**ADDENDUM 1
RFB 18-0011
MURDOCK TAG REMODEL**

SEDGWICK COUNTY OMD REMODEL

Prepared by:
Schaefer Johnson Cox Frey Architecture, Inc.

A21.1R

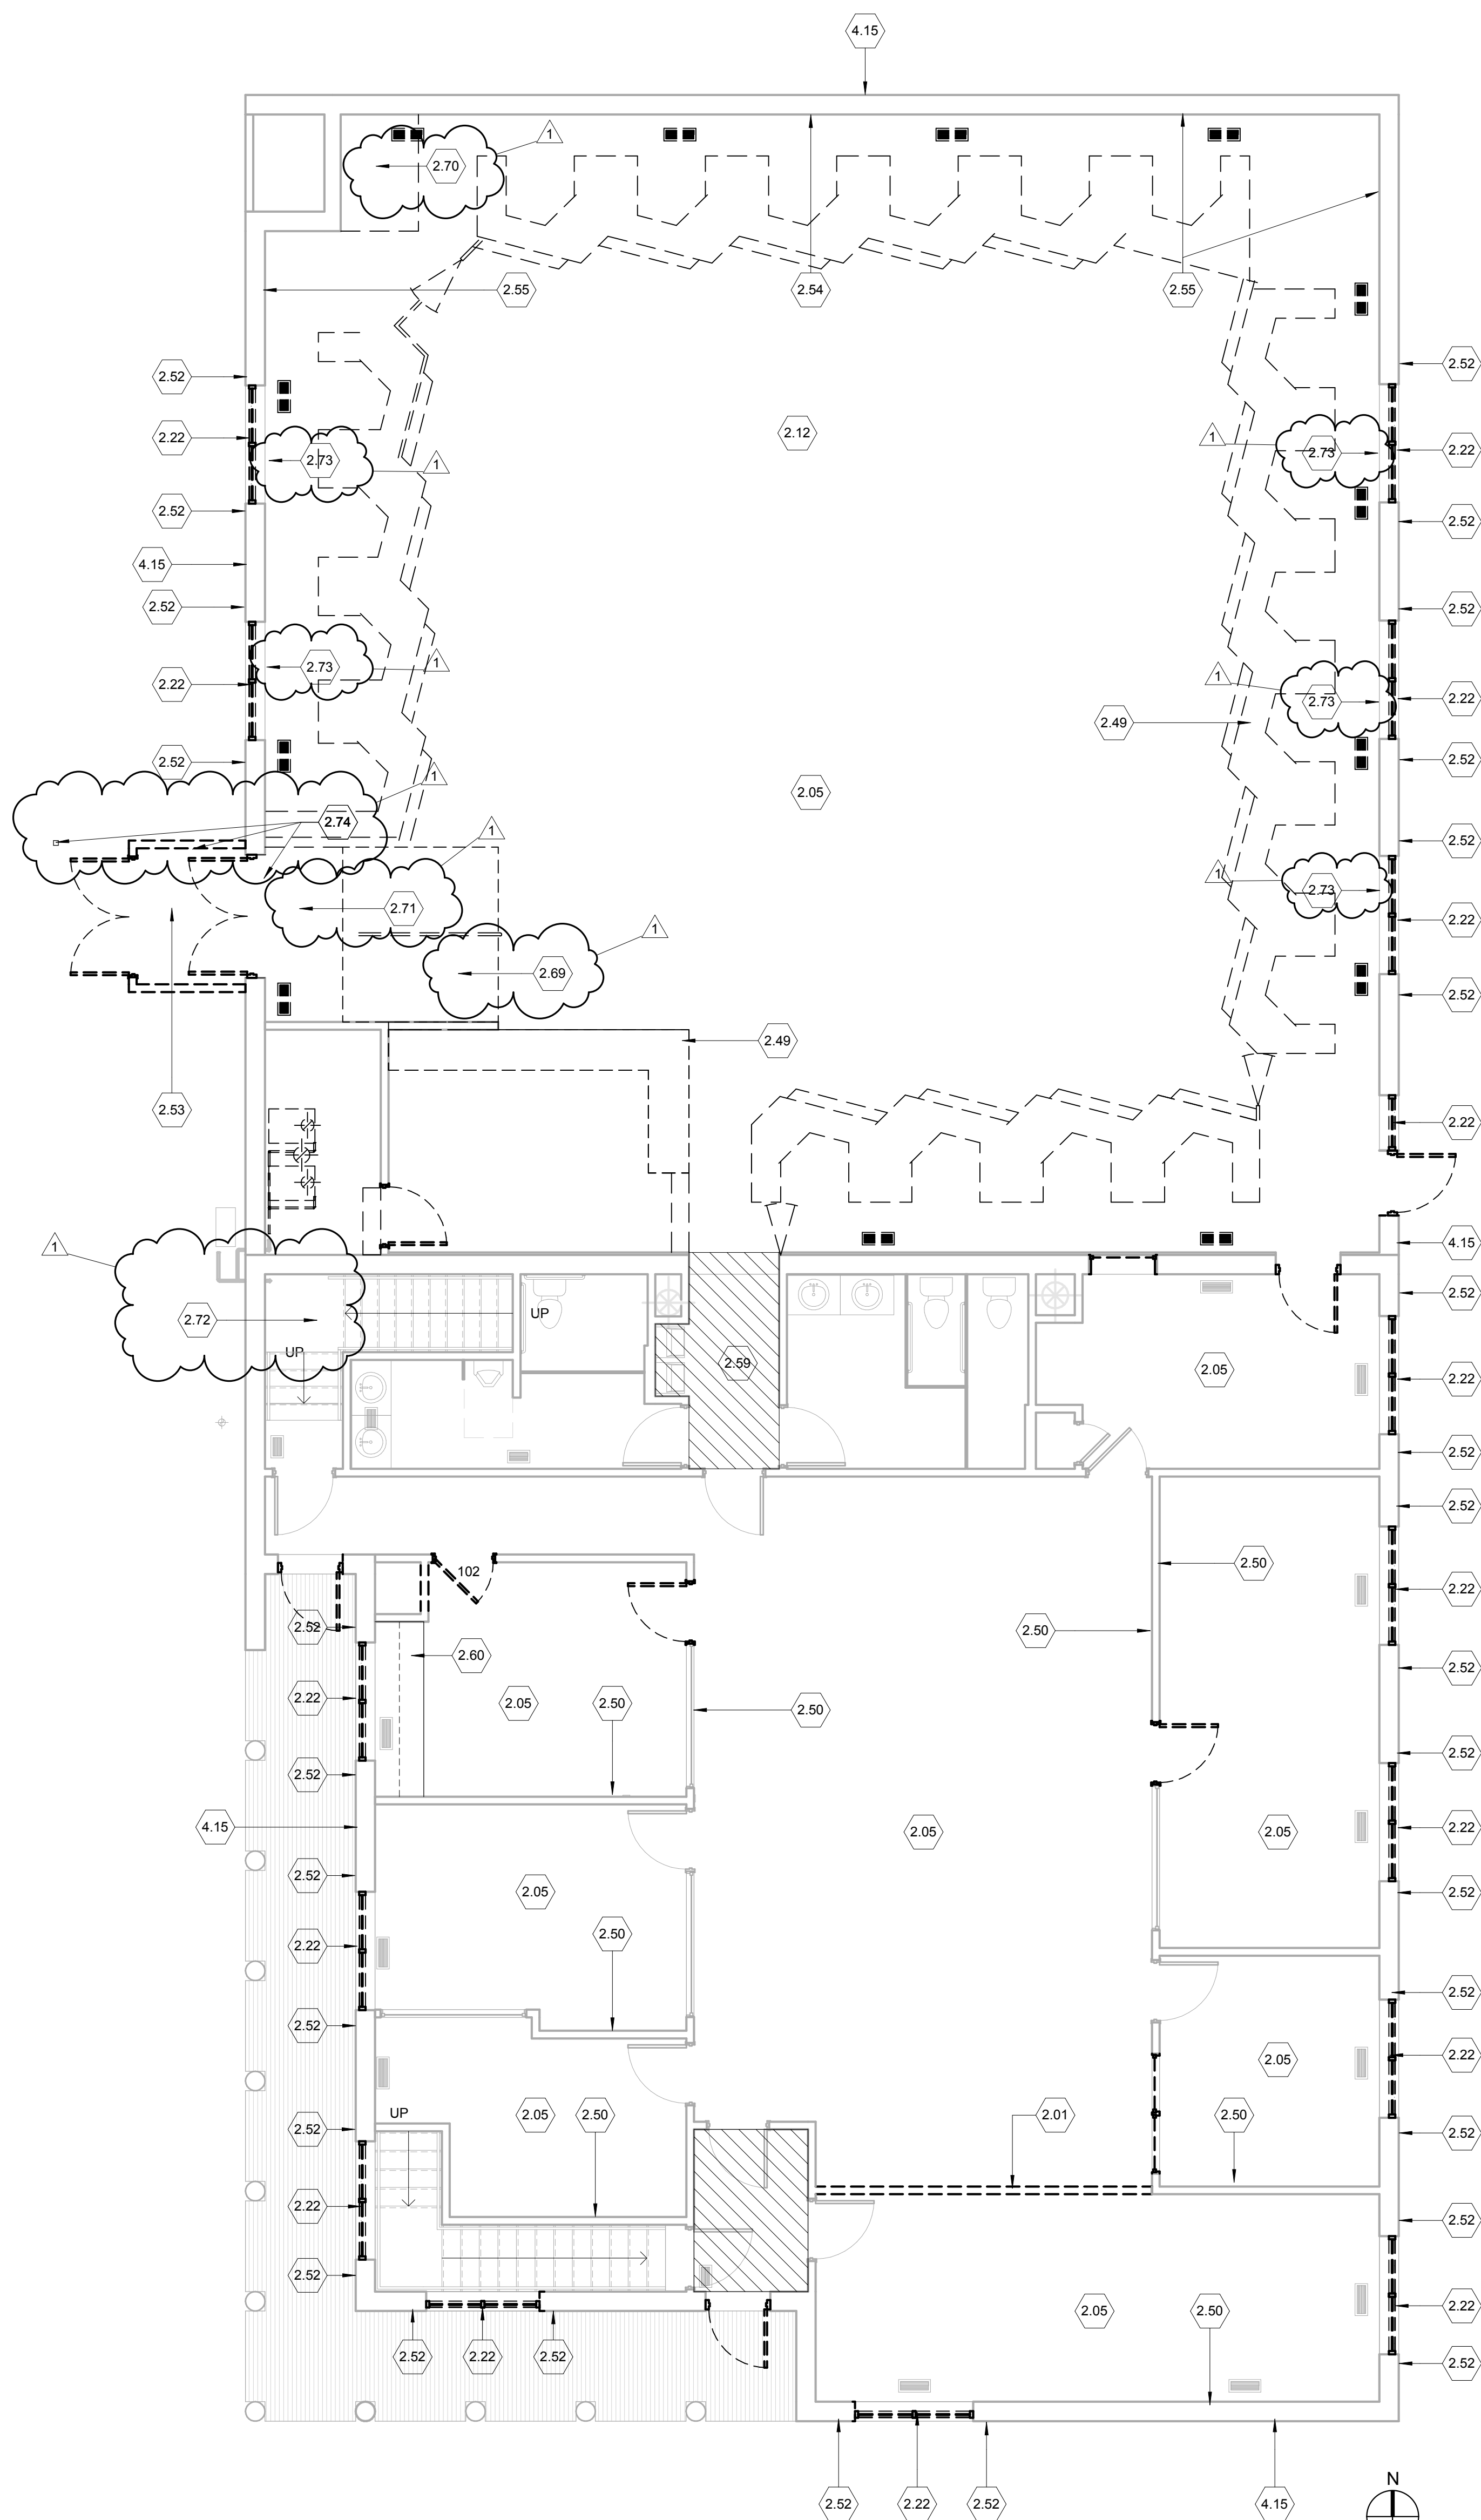
DRAWING SHEET, A21.1, KEYED NOTES:

Replace drawing sheet A21.1 with attached drawing sheet A21.1R including revisions for keyed notes 2.69, 2.70, 2.71, 2.72 and 2.73.

- 2.59 EXISTING ROOFTOP UNITS TO REMAIN. PROVIDE NEW PITCH PANS AT EXISTING ELECTRICAL PENETRATIONS.
- 2.60 EXISTING PARTS TO REMAIN.
- 2.69 REMOVE CONCRETE RAMP. PATCH FLOOR AND PATCH AND PAINT ADJACENT WALLS AS REQUIRED TO MATCH ADJACENT SURFACES WHERE LEFT EXPOSED.

- 2.70 REMOVE CONCRETE LANDING TO GREATEST EXTENT POSSIBLE. PATCH FLOOR AND PATCH AND PAINT ADJ. WALLS AS REQ'D TO MATCH ADJACENT SURFACES WHERE LEFT EXPOSED.

- 2.71 EXISTING LANDING TO REMAIN.
- 2.72 REMOVE EXISTING STAIR NOSING AND PREP FLOOR FOR NEW FLOORING.
- 2.73 REMOVE CURTAINS AND VALANCE FROM WINDOW.
- 2.74 SALVAGE AUTOMATIC OPERATOR AND BUTTONS AND DELIVER TO OWNER.

A22.1R

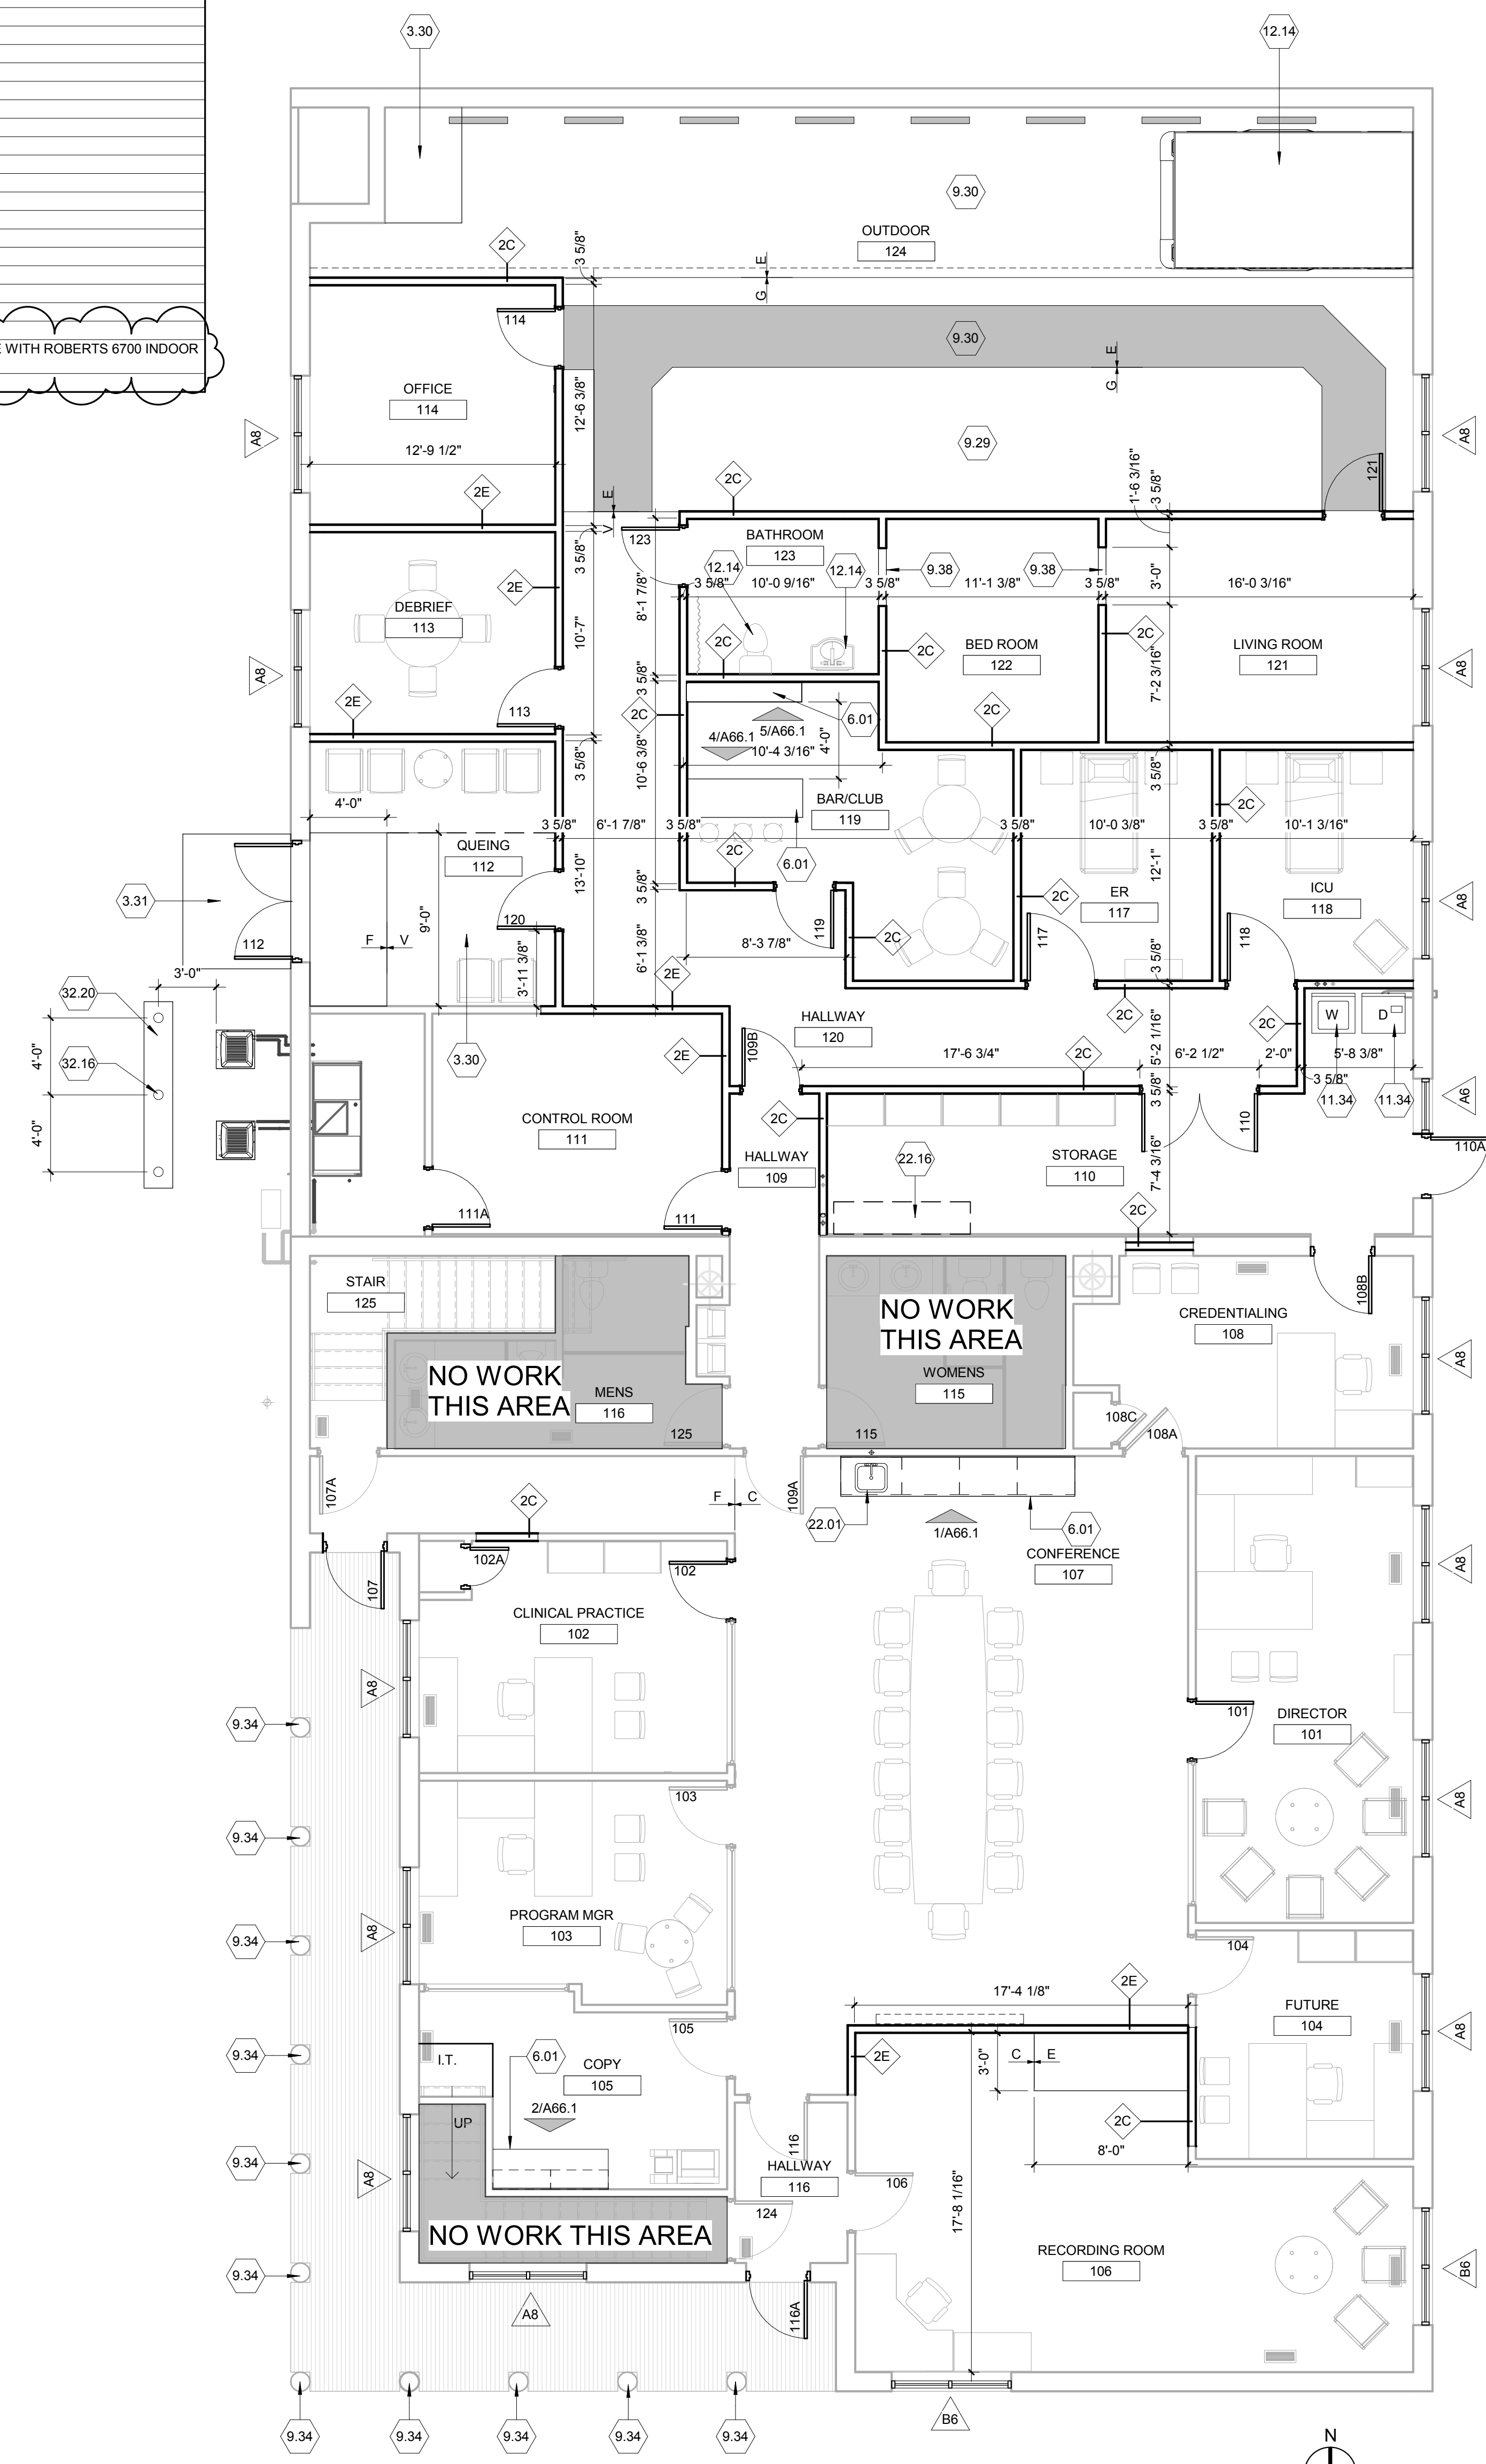
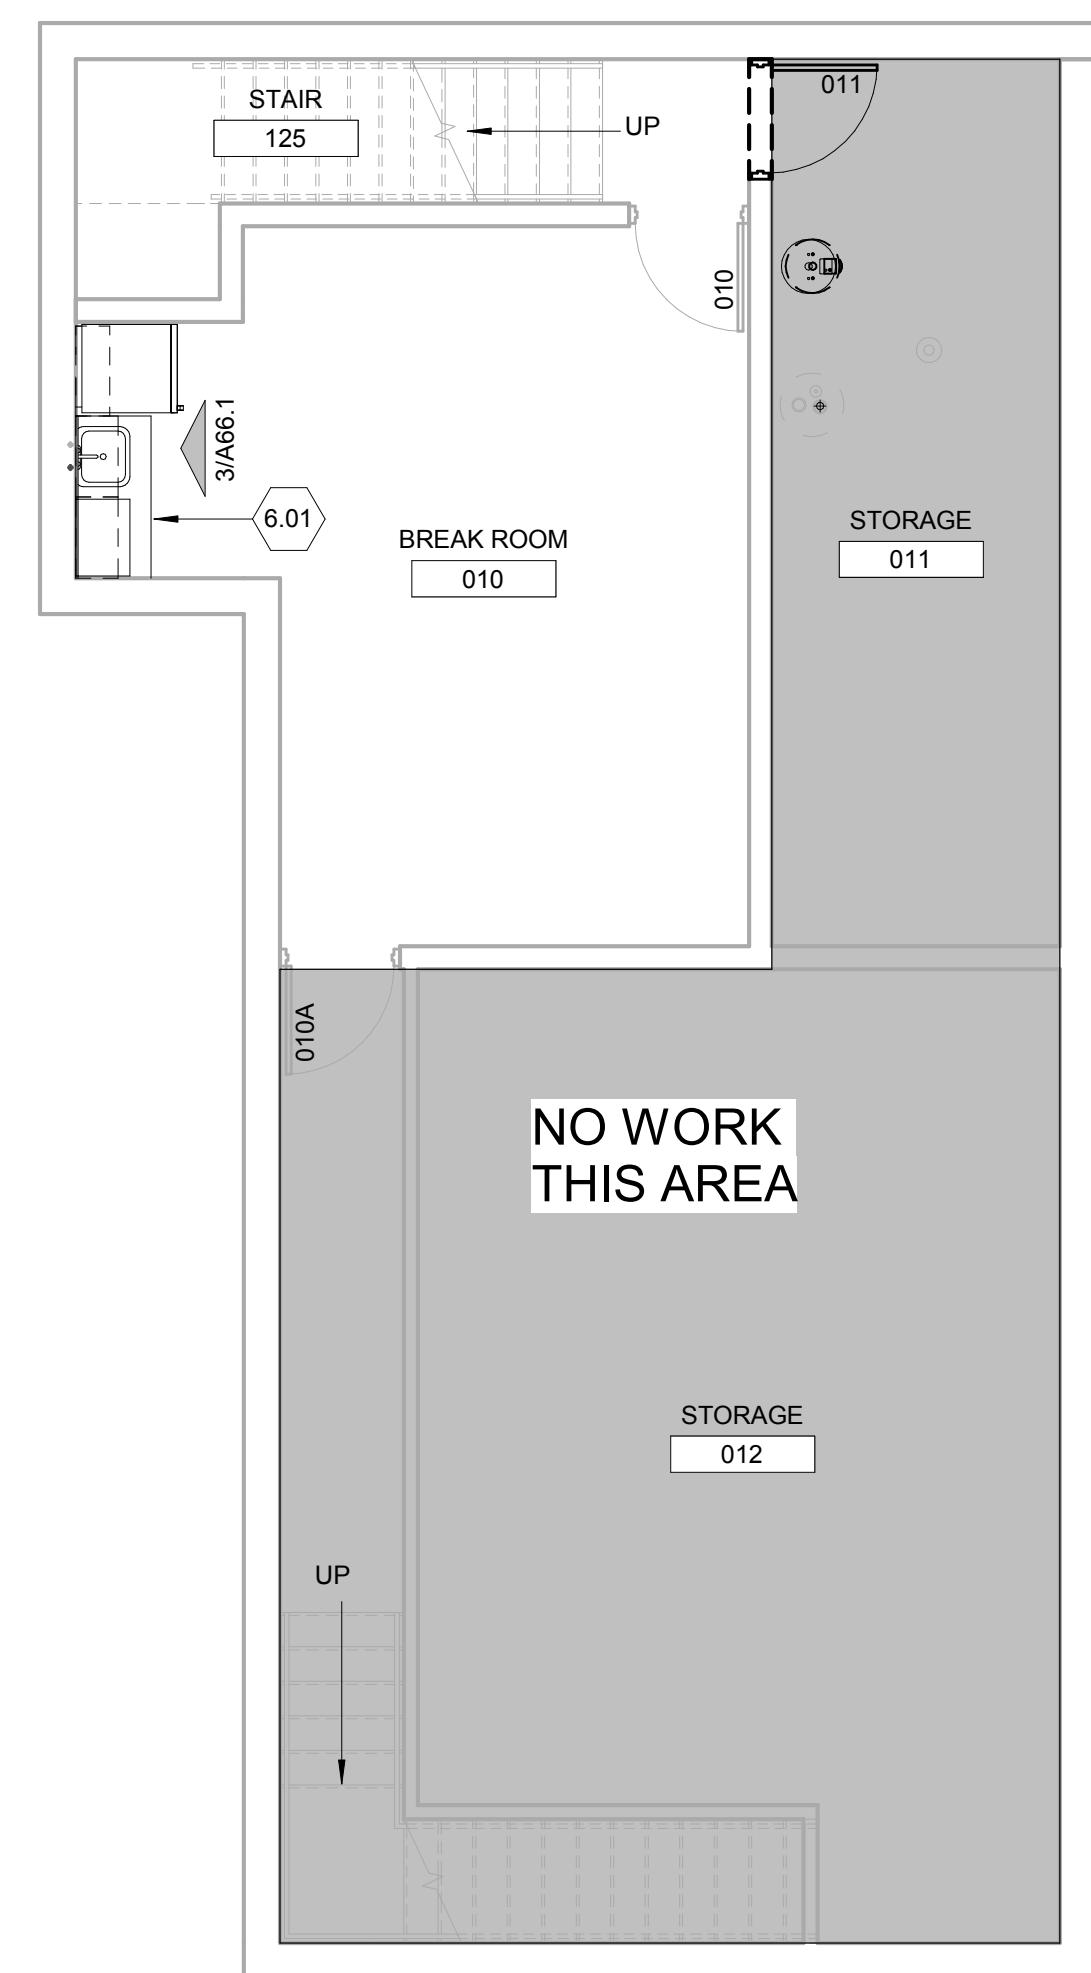
PREBID MEETING, Queuing Room 112:

After concrete ramp is removed up to the landing, there will be an approximate 7" high landing inside door 112.

- 3.30 INFILL CONCRETE FLOOR SLAB WHERE RAMP WAS REMOVED.
- 3.31 POWER WASH/SANDBLAST EXISTING SLAB AS REQ'D TO REMOVE GLUE FROM ENTRY MAT.
- 6.01 ARCHITECTURAL WOOD CASEWORK - REF. MILLWORK ELEVATIONS, DETAILS AND SPEC.
- 9.29 IMITATION GRASS - FULLY ADHERED, REF. FINISH SCHEDULE.
- 9.30 EPOXY PAINTED FLOOR, REF. SPEC.
- 9.34 PAINT EXTERIOR COLUMNS, TYP.
- 9.38 3'-0" X 6'-0" FINISHED OPENING.
- 11.34 WASHER/DRYER FURNISHED BY OWNER, INSTALLED BY CONTRACTOR.
- 12.14 PROPS BY OWNER
- 22.01 SINK - REF. PLUMBING
- 22.16 CADAVER SINK FURNISHED BY OWNER, INSTALLED BY CONTRACTOR.
- 32.16 STEEL BOLLARD FILLED WITH CONCRETE - REF. DETAILS.
- 32.20 CONCRETE STRIP AT BOLLARDS
